20 September 2019

St Aloysius' College Redevelopment (SSD 8669)

Figure 10: Proposed Northern Elevation - Main Campus (Source: Applicant’s RfS)

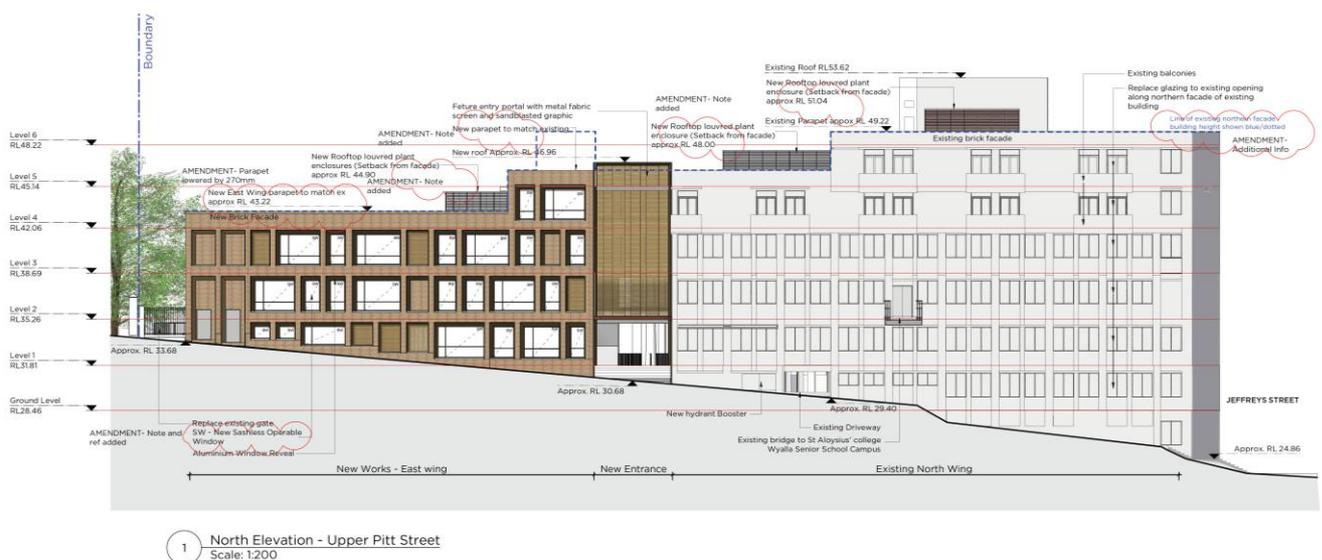
137. The Application assessed by the Department comprised three additional plant enclosures along the northern wing of the Main Campus building (Figure 10).

138. The Department’s Assessment Report concluded that the impacts of the rooftop plant would be offset by the improved views due to the removal of the existing stairwell (shown in Figure 10). The Department recommended a condition of consent to address the design of rooftop plant enclosures which states:

“Prior to the issue of a construction certificate for the Main Campus, details must be submitted to the satisfaction of the Planning Secretary of the minimum horizontal and vertical envelopes required for the enclosure of rooftop plant and equipment on the Main Campus.”

Figure 11: Plane drawn from northern parapet to southern parapet of the proposed replacement building - Main Campus (Source: Department's Assessment Report)

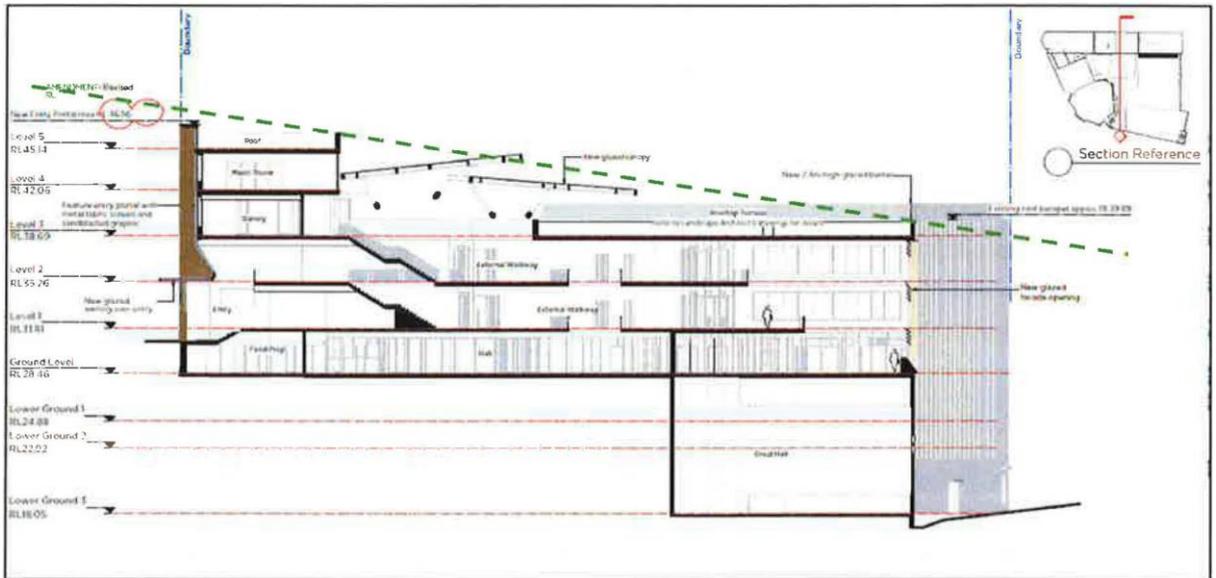
that the impacts on these residences would be minimal provided:

- all structures (including permanent and temporary structures) and plantings (at maturity) are kept below a plane drawn from the top of the southern parapet of the replacement north-east wing building and the top of the existing parapet of the southern elevation of the south-eastern wing building [see Figure 11];
- the proposed glazed balustrade around the perimeter of the rooftop terrace is frameless and the structural supports do not extend above the existing parapet of southern elevation of the south-eastern wing building as proposed in the RtS; and
- the glazed balustrade is low iron glass to maximise transparency.

163. The Commission agrees with the Department’s conclusions about the proposed landscaping and other permanent structures on the rooftop terrace and supports its recommended condition to limit these structures to not extend above the plane between northern parapet and southern parapet (see paragraph 139).

Figure 12: Extract of proposed amended Main Campus rooftop - revised locations of rooftop plant shown in red (Source: Applicant's Additional Information dated 29 August 2019)

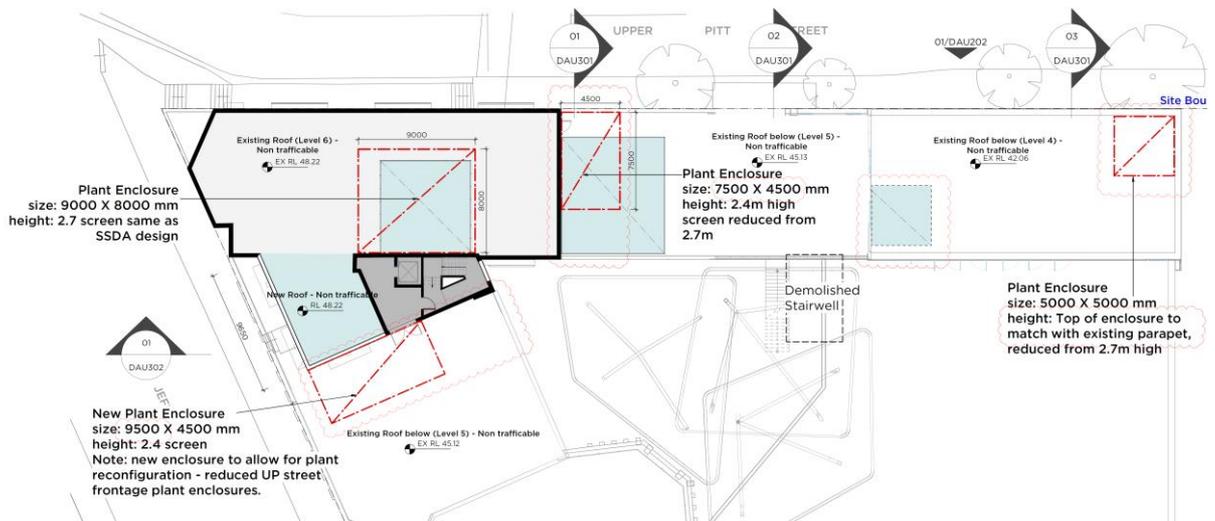
148. The Commission requested the Applicant to consider redesigning and/or relocating the mechanical plant enclosures to avoid the need to build additional structures on the rooftop and minimise visual impacts to neighbouring residences.

150. The Applicant also revised its proposed plans which indicate the plant enclosures could be relocated and a new plant enclosure constructed immediately to the south of the existing lift overrun and plant room in the north western corner of the Main Campus building (see Figure 12).

151. While this may represent an improved visual outcome, the Commission is not satisfied that the Applicant has provided sufficient information to justify installing mechanical plant enclosures externally on the Main Campus and it considers the design and location of the rooftop plant should be further reviewed in order to further minimise visual impacts and improve the proposal's consistency with the principles of clause 35(6) of the Education SEPP, without compromising the operational performance of the building.

152. In particular, the Commission notes that the principles in clause 35(6) of the Education SEPP including “context, built form and landscape” require a consideration that “schools should respond to and enhance the positive qualities of their setting, landscape and heritage...”. The Commission acknowledges the community’s concern that structures on the roof such as plant enclosures are not “positive qualities” of the existing setting and additional roof top structures would not “enhance” this setting.

153. Furthermore, the Commission notes that the Application’s proposed development at the Main Campus involves significant internal changes and additions to the existing built form and extra gross floor area. There would be opportunities to include the plant within the building envelopes, subject to internal redesign and appropriate facade treatment to provide air circulation, rather than providing additional structures on the roof.

154. The Commission has therefore imposed a condition of consent requiring all new rooftop plant and equipment to be wholly contained within the building envelope and to not be separate rooftop elements.

155. However, the Commission recognises that there may be technical constraints to locating all mechanical plant externally. Therefore, the Commission has also included conditions permitting the construction of rooftop plant as separate elements subject to a technical justification from an independent qualified mechanical engineer demonstrating that internal construction is not technically feasible, and for detailed designs of enclosures:

- that are of the minimum horizontal and vertical dimensions required for the enclosure of the plant and equipment;
 - to be located to minimise impacts on the streetscape and on views from the public domain and residential properties; and

Figure 14: Amended Junior Campus building envelope (Source: Applicant's Additional Information dated 15 August 2019)

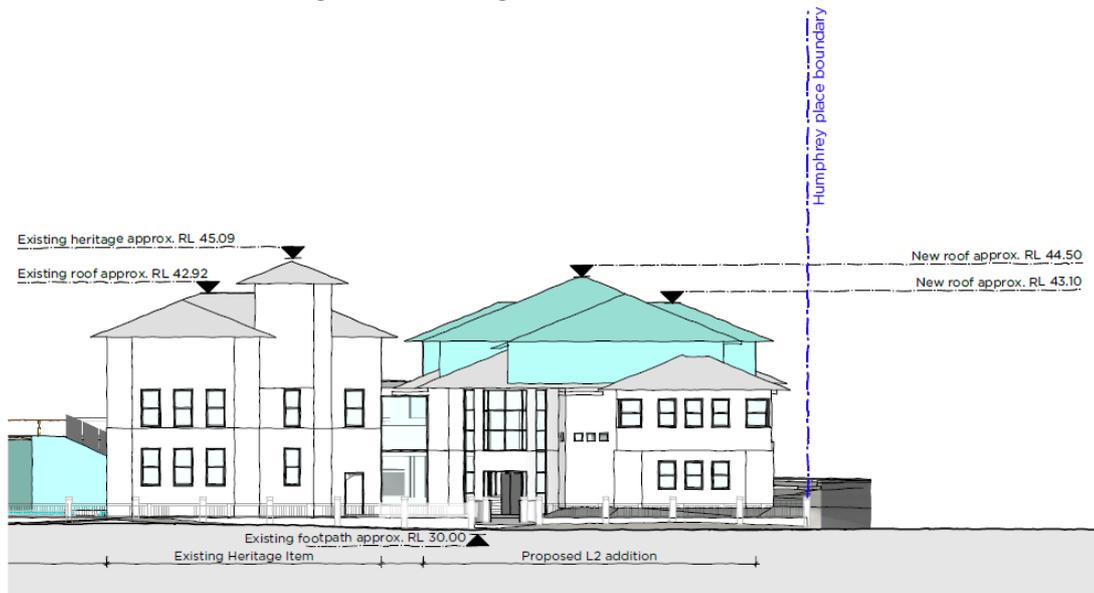
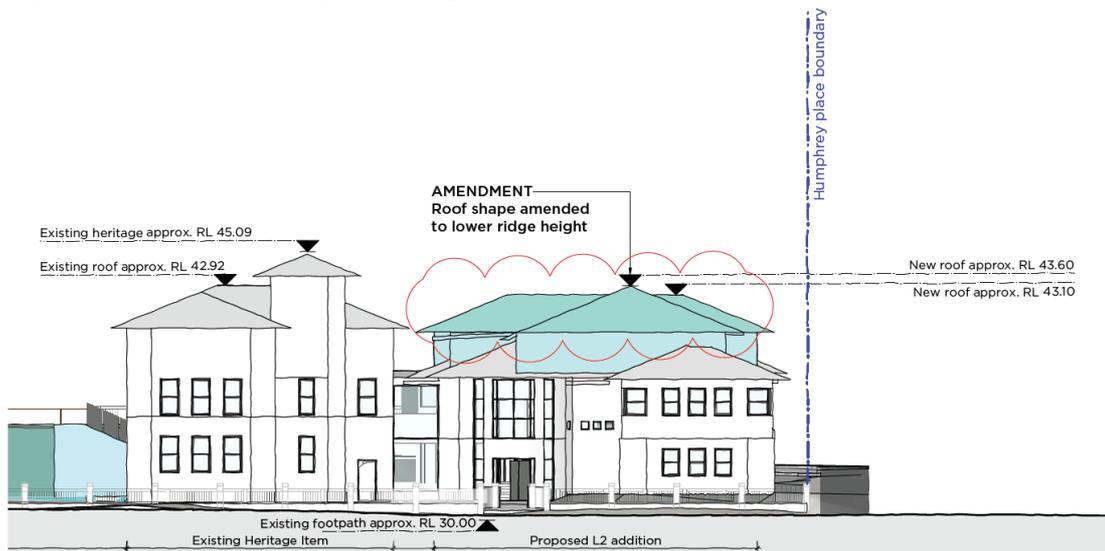
179. Given the concerns about the relationship of the proposed additional level on the western building at the Junior Campus with the existing tower on the heritage building, the Commission sought further consideration by the Applicant of the proposed design of the roof form of the addition at the Junior Campus.
180. The Applicant amended its Concept Proposal designs for the proposed additional level to change the roof form and reduce the maximum height from approximately 12 metres to 11 metres as indicated in Figure 13 and Figure 14.

“the revised concept plans for [the] Junior School provided to the Commission on 15 August 2019 are an amendment to the Concept Proposal development application and are to supersede the corresponding documentation under the proposed Schedule 2 Condition A4.”
